UNITED STATES PATENT AND TRADEMARK OFFICE

APPLICATION NO.	FILING DATE	FIRST NAMED INVENTOR	ATTORNEY DOCKET NO.	CONFIRMATION NO.
10/623,355	07/18/2003	John Paul Mizzer	DCS-9129	5039

Office Action Summary

Fig. 2

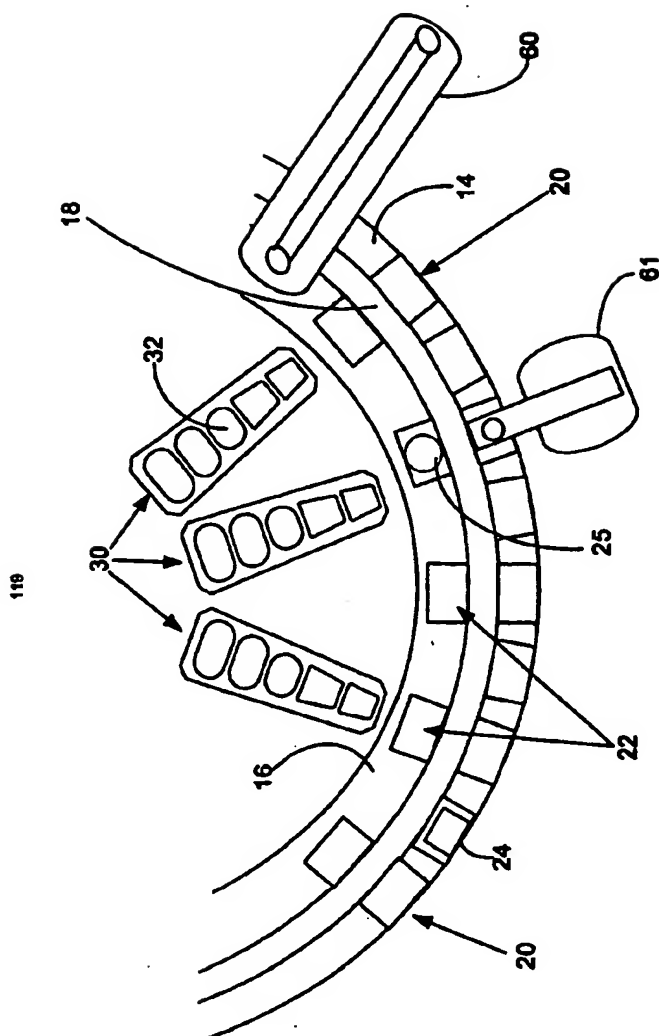
1. Figure 2 should be designated by a legend such as --Prior Art-- because only that which is old is illustrated. See MPEP § 608.02(g). Corrected drawings in compliance with 37 CFR 1.121(d) are required in reply to the Office action to avoid abandonment of the application. The replacement sheet(s) should be labeled "Replacement Sheet" in the page header (as per 37 CFR 1.84(c)) so as not to obstruct any portion of the drawing figures. If the changes are not accepted by the examiner, the applicant will be notified and informed of any required corrective action in the next Office action. The objection to the drawings will not be held in abeyance. Figure 2 is an enlargement of a portion of figure 1 which is prior art. Examiner notes that a replacement sheet was received, however there was no prior art label added. Thus the objection is being maintained.
